SUBJECT: Contract 8127  
Snowshed to Keechelus Dam Phase 1C – Replace Snowshed and Add Lanes  
State Project  
Change Order No. 73 “Add Snow Nets-Sector 14”

**WASHINGTON STATE  
DEPARTMENT OF TRANSPORTATION  
CHANGE ORDER**

CONTRACT NO: 008127 FEDERAL AID NO:  
CONTRACT TITLE: I-90, SNOWSHED TO KEECHELUS DAM PHASE 1C - REPLACE  
CHANGE ORDER NO: 73 ADD SNOW NETS-SECTOR 14

# Avalanche Mitigation Concept

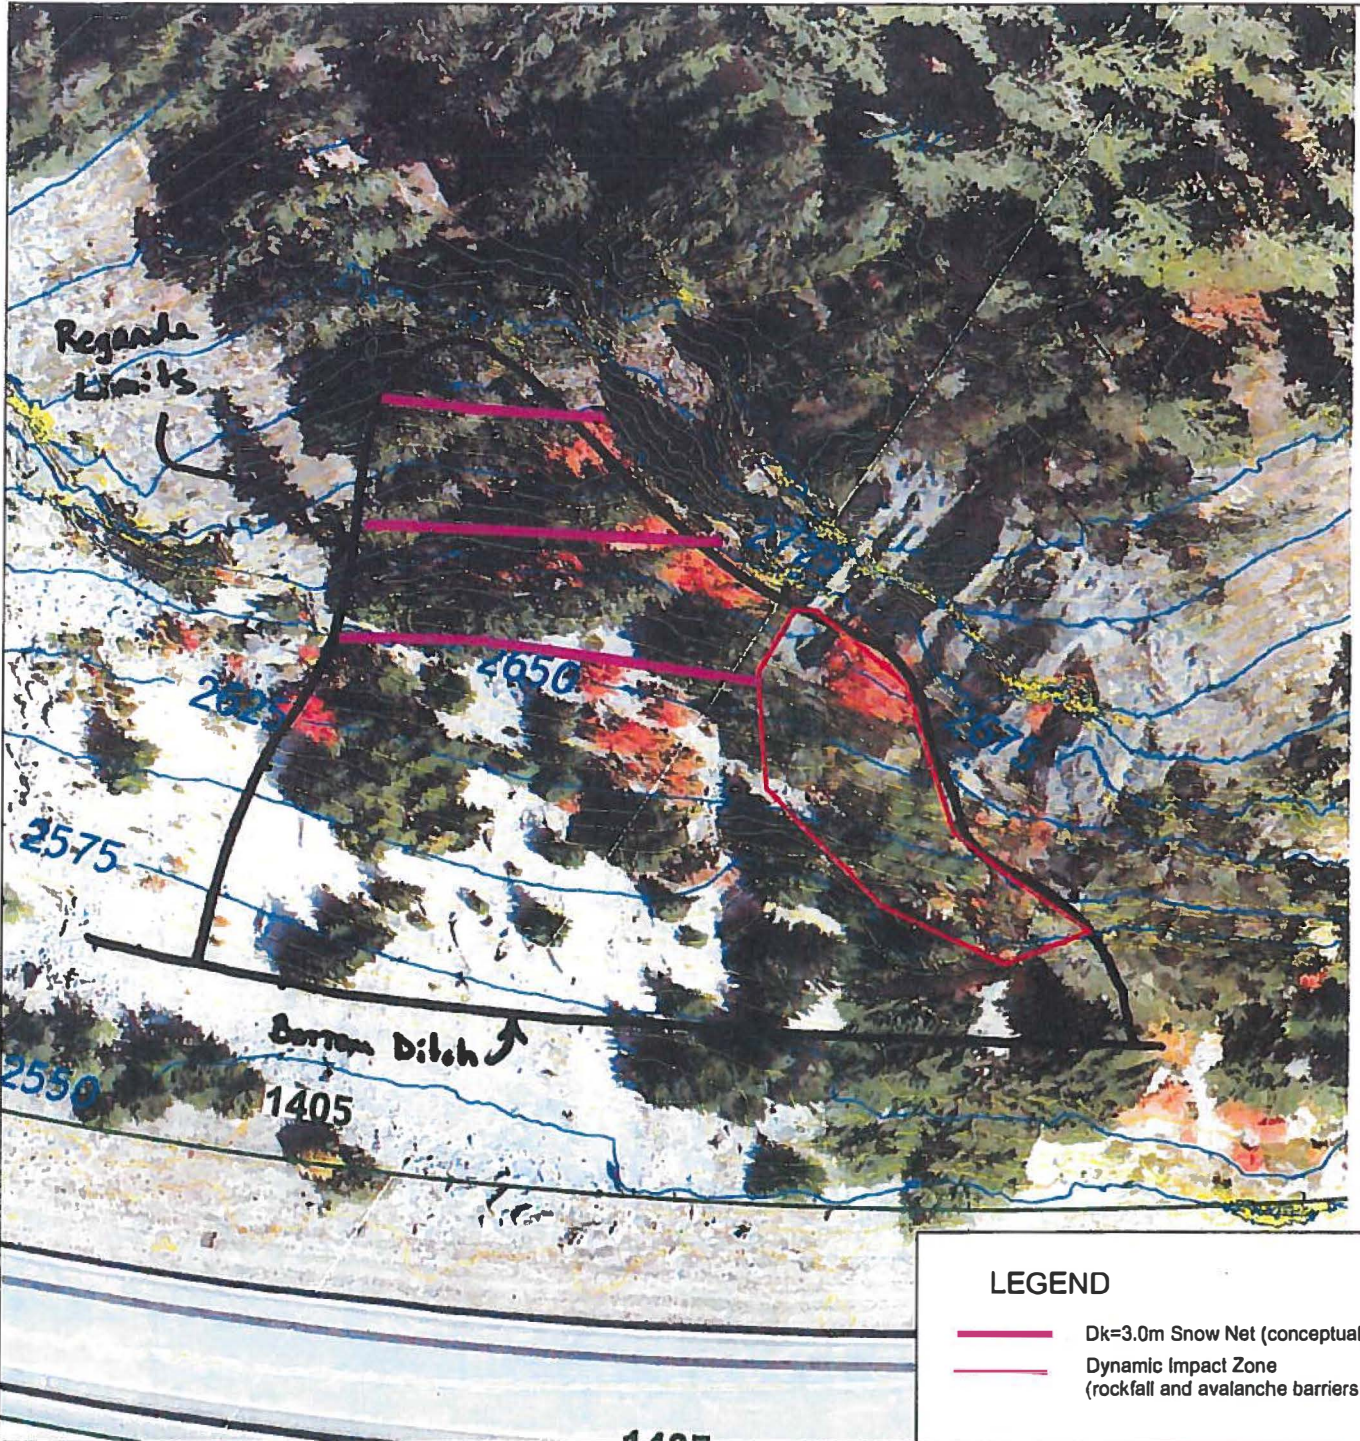
This change order provides full compensation for all designing, furnishing, assembling and installing snow nets within the limits shown on page 5 of this change order. These snow nets shall be located in the area of steep slope excavation addressed by change order 47 (Approximate Station LW 1405+00 to 1407+25).

All snow nets added by this change order shall be in place and operational prior I-90 traffic being placed on the final LW alignment below these fences.
